Reponse to reviewer #1: manuscript 2023-191

Pico-Light H<sub>2</sub>O: Intercomparison of in situ water vapour measurements during the AsA 2022 campaign.

Response to reviewer #2: manuscript 2023-191

By Ghysels et al.

**Figure 8: Profiles of RH (black) and RH<sub>i</sub> (grey) for the flights of September 19, 21 and 23, 2022, from Aire-sur-l'Adour (France). Dash lines are the calculated saturation relative humidity (SRH).**

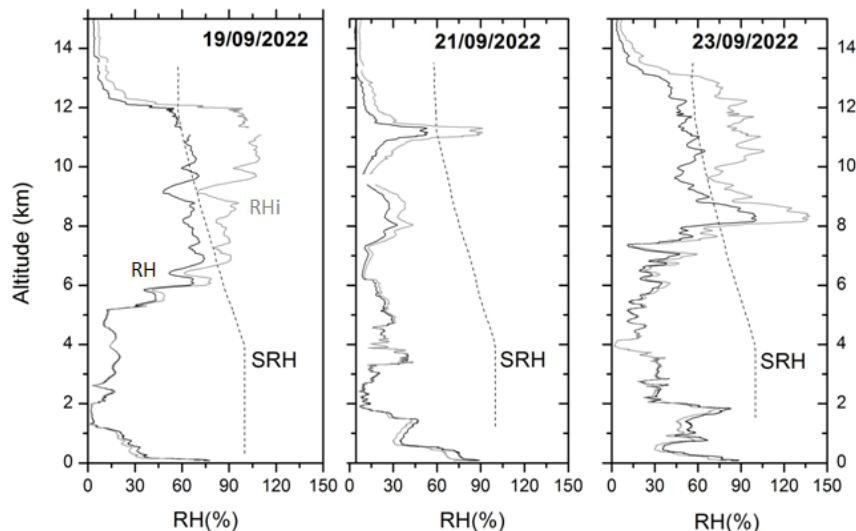
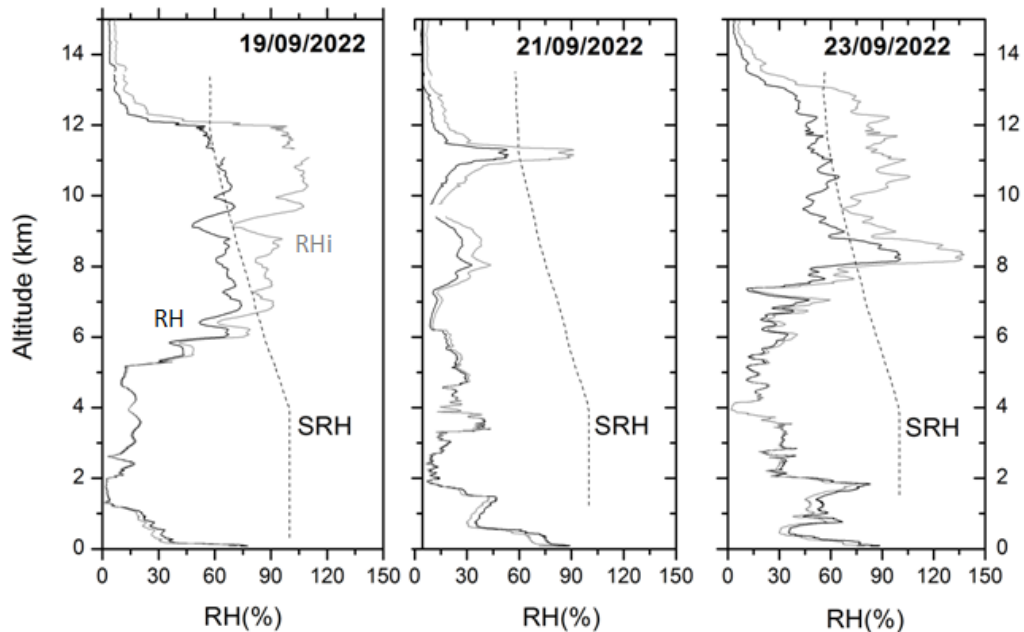
Figure 8: Which saturation mixing did you choose in case of the PICO-Light ? Is the entire profile showing  $S_{ice}$  or  $S_{liq}$  or was the same procedure applied as for the FPH ?

Line 476-479: Actually I cannot really believe that in the entire altitude range of 7.5 to 13 km you will still find a mixed-phase cloud with both  $S_{ice}$  and  $S_{liq}$  below 1. In case there are ice particles actually all droplets would quickly evaporate and increase the size of the ice particles. In addition below  $-38^{\circ}\text{C}$  all liquid droplets would freeze instantaneously and form ice particles. And typically ice should not yield to large contamination. I guess the contamination is just coming from the small layer where you reach also the  $S_{liq}$  close to 1. There I agree that this might be a mixed phase cloud. Could be from convective origin ? Another thing which I do not understand is, why you still see contamination of during descent down to 18km? Is it because of the optical cell is contaminated by water ?

Another concern is regarding the caption of Figure 8, "Dash horizontal lines show the altitude where ice phase is found on FPH mirror for each flight. Saturation ratios during the ascent are given over ice above this altitude and over liquid water below." Before explaining my concern, let me confirm that saturation ratio (in unit 1) is equivalent to relative humidity (in unit %) (and Figure 8 and Figures 11/12 are somewhat redundant). Am I correct?

Changing relative humidity (or saturation ratio) definition depending on the phase of condensate on the chilled mirror of NOAA FPH is not very appropriate for the purpose here. The phase of the condensate is nothing to do with the environmental conditions whether water vapor could be condensed as liquid water or ice. Instead, the two phases of the condensate should be viewed as just two different "sensors" for the atmospheric water "vapor" pressure. If the condensate on the mirror is liquid (ice), then we use the Clausius-Clapeyron equation for liquid (ice) to calculate the water vapor pressure values. Thus, we

need to know the phase of condensate when converting NOAA FPH temperature values to water vapor pressure values, but changing the definition of RH/S (i.e. which is to be used for the denominator, liquid or ice version of CC eq.) depending on the FPH condensate phase is nonsense. Probably, the best way is to use always RH (or S) over liquid, as done for “Figure 11” following the convention applied for radiosonde RH sensors, and add ice saturation curve for atmospheric temperatures below 0 deg. C in the figure. In this way, we can easily see whether the upper tropospheric wet layer is close to ice saturation (e.g. when it is close to the ice saturation curve) or even close to water saturation (when it is close to 1 or 100%). Section 4 and Fig. 1 of the paper by Fujiwara et al. (2003) may be useful for these calculations and an example of ice saturation profile. (Note that the comparison results, i.e. relative differences, would not be affected by this revision.)

Author: we revised this section. Figure 8 has been revised, showing Pico RH and RH<sub>i</sub>, together with the SRH curve to help in the interpretation.

Author : We revised this paragraph, refining our description and analysis.

"On the flights of the 19th and 23rd, thick saturated layers are found (RH or RH<sub>i</sub>>SRH). Particularly, on the 23rd, between 8 and 9 km, a layer of RH>SRH is found. Additionally, a thick layer of air saturated over ice expands from 8 to 13 km, though bringing less contamination compared to the case of RH saturation (found between 8 and 9 km). In this case, both Pico-Light and FPH have flown through a mixed phase cloud between 8 and 9 km. For this flight, the outgassing contamination is the largest during the ascent and affect measurements down to 20 km during the descent. This is due to liquid droplets and or ice particles (to a lesser extent) sticking to the balloon and parachute while ascending through the cloud, which then evaporated or sublimated during the rest of the ascent. Similar behaviour is observed for the flight of the 19th, but to a lesser extent. In the case of the flight of the 19th, the balloon flew through a thick layer between 9.5 and 11.6 km, where the RH is above SRH. Between 6 and 12 km, the RH<sub>i</sub> is above SRH (RH<sub>i</sub>>100%). In this case, both Pico-Light and FPH have flown through a thick ice cloud within which

mixed phase layers are found. The presence of such thick cloud is confirmed by EUMETSAT (not shown) cloud top observations (so is the case for September 19th). EUMETSAT has observed cloud tops nearby 11.5 km. The situation on the 21st is dramatically different, only a thin layer where RH is above SRH (altitude between 11 and 11.3 km). Then, on the 21st, flights have been realized under clear sky conditions."

Author: Thank you for this suggestion. We changed the figure 8 to the present one, in order to make easier the interpretation:

The paragraph has been revised accordingly (see lines 473-488).

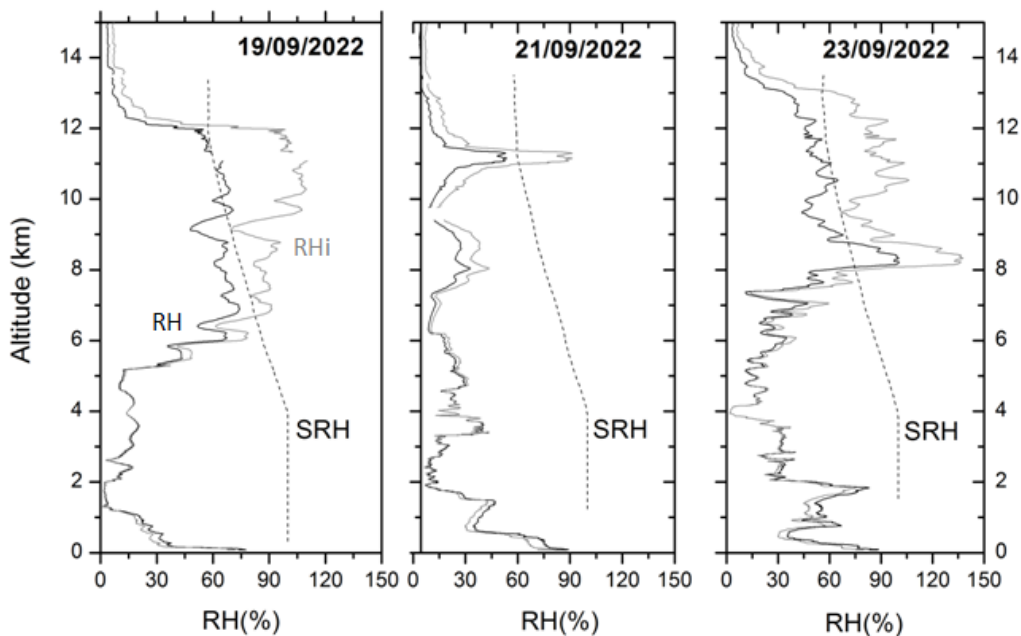
First of all, I am afraid that the current Figure 11 should be actually "Figure 12" for M20, and Figure 11 for iMet-4 is missing.

Author: This is a mistake, thank you for bringing this up. Corrections have been applied. The comparison with iMet-4 is only shown in the table 6.

Author: Yes, they are somewhat redundant since only the M20 measurements are missing in figure 8 as well as the relative difference panels.

Figure 6: Vertical profiles of water vapour on September 19, 21 and 23, 2022 from Pico-Light H<sub>2</sub>O (black line) and NOAA FPH (red line).

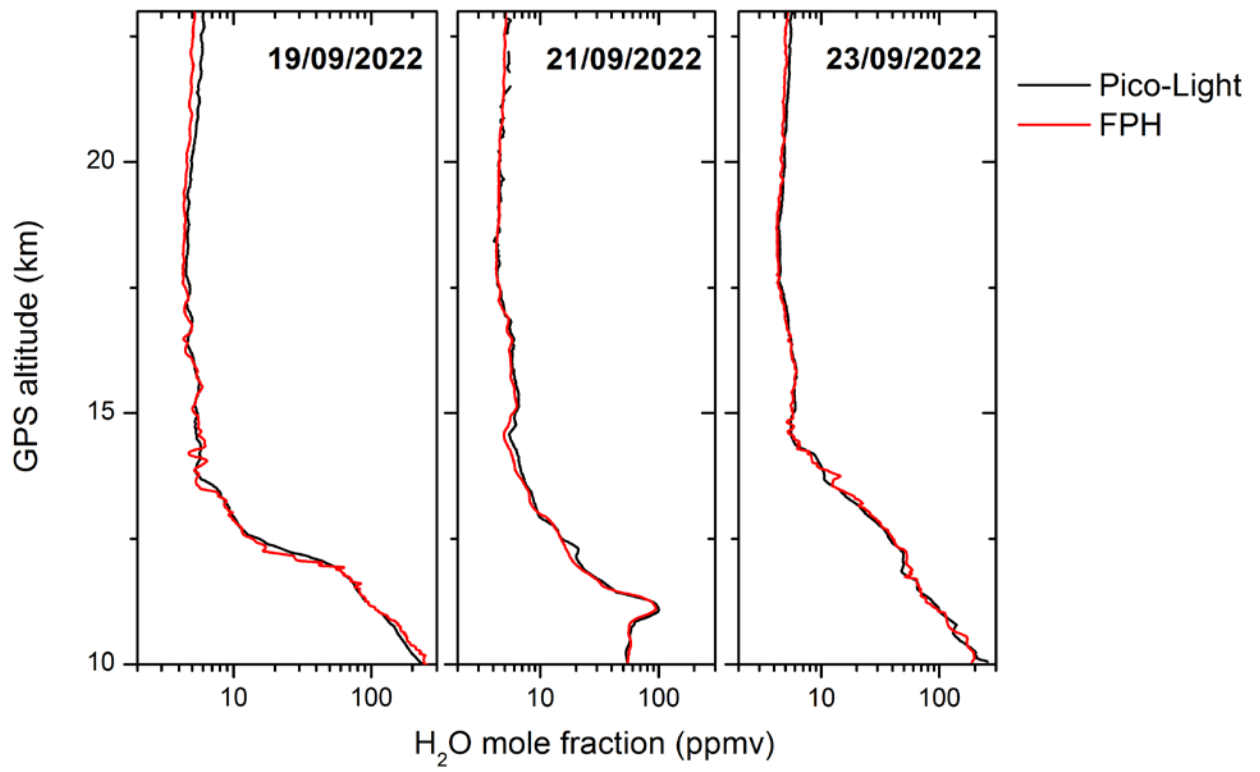
(3) Figures 6, 8, 11, and 12 (although 11 or 12 is missing)

Please prepare different panels for different days. Currently, different days are mixed in one panel, so that the characteristics of the profiles are not easy to grasp.

Author: Noted.

The figures have been updated accordingly such as:
